U.S. Department
of Transportation
Federal Highway
Administration

In Reply Refer To:
HSSD/B-156

In your letter of December 13, 2006, you requested the Federal Highway Administration's (FHWA) acceptance of Single-Sided and Double Sided Thrie-Beam called the GMS-TB Guardrail System at the National Cooperative Highway Research Program (NCHRP) Report 350 test level 3 (TL-3). To support your request, your company sent a copy of the Southwest Research Institute report dated November 30, 2006, entitled "NCHRP Report 350 Test 4-11 Full-Scale Crash Evaluation of a Single-face GMS-TB Guardrail System" and digital videos of the crash test conducted on the GMS-TB Guardrail System. You also requested the waiver of tests 3-10 of the Single-Sided and Double Sided GMS-TB Guardrail System and test 3-11 of the Double-Sided GMS-TB Guardrail System.

GREGORY MINI SPACER

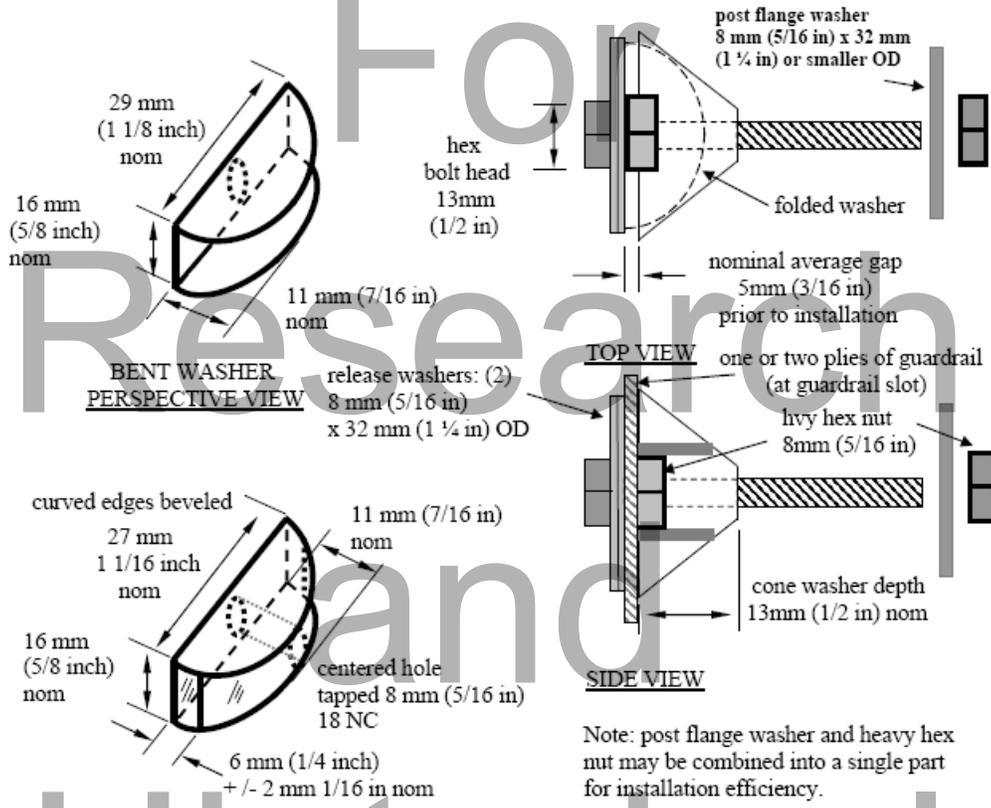
SGR09 (a,b,c) Thrie-Beam systems and accounts for higher centers of gravity of the current vehicle fleet. The ground clearance of the system is 483 mm (19 in), which is the same ground clearance that was used in the W-beam GMS designs previously accepted by the FHWA (acceptance letter HSA-10/B150). The proprietary GMS fastener is a critical element of the system. It ensures that Thrie-Beam panels disengage from the posts on impact and are not pulled down to the ground and rotated by the posts. Such performance lowers the probability of vehicles overriding the system. Also, posts disengaged from the guardrail have less of a snagging potential compared to posts attached to the guardrail. Design details for the proprietary GMS fastener are shown in Enclosure 1.

Figure A.1 – Gregory Industries Single-Face GMS-TB Guardrail System

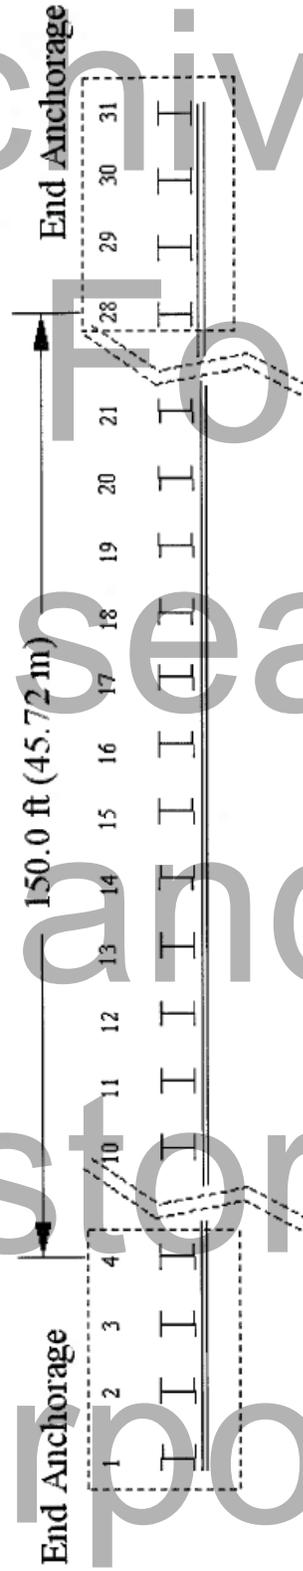
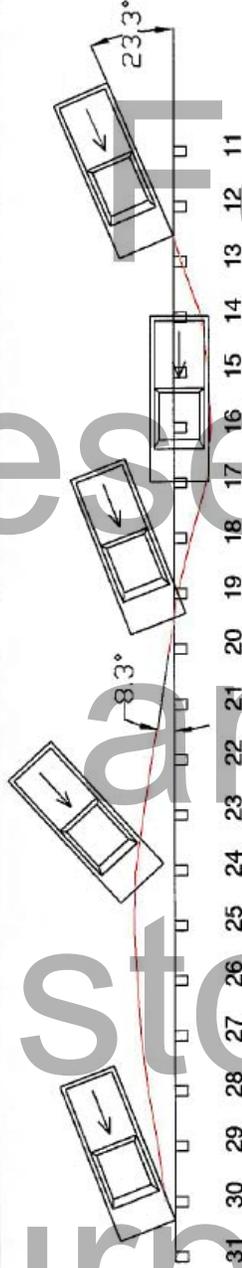
Full-scale crash testing to evaluate the impact performance of the GMS-TB Guardrail System included test 3-11. The results of this test are summarized in Enclosure 2. A comparison of the test results with the evaluation criteria set forth in the NCHRP Report 350 indicates compliance with all recommended criteria for the test performed.

The GMS-TB Guardrail System performed as intended. In the posts that were directly contacted by the test vehicle (Posts 13 through 19), the guardrail was released from the posts. In the vehicle contact region, all of the fasteners were sheared at the front face of the post during the impact of the vehicle with the guardrail and posts, except for Post 16 where the fastener was not sheared. All of these fasteners exhibited a uniform U-shaped deformation of the release washers. Outside of the vehicle contact region, the fasteners in Posts 20 through 24 released from the guardrail without being sheared, and in Post 25 the fastener released from the guardrail and was sheared at the front face of the post. These fasteners also exhibited a uniform U-shaped deformation of the release washers. None of the Thrie-Beams failed and all of the splice joints remained fastened together. The guardrail was not smashed flat at any of the posts in the impact region and for the most part maintained its Thrie-Beam shape.

In summary, I agree that both Single-Sided and Double Sided GMS-TB Guardrail Systems, as described above, meet the appropriate evaluation criteria for NCHRP 350 TL-3 devices and may be used at all appropriate locations on the National Highway System (NHS) when selected by the contracting authority, subject to the provisions of Title 23, Code of Federal Regulations, Section 635.411, as they pertain to proprietary products.
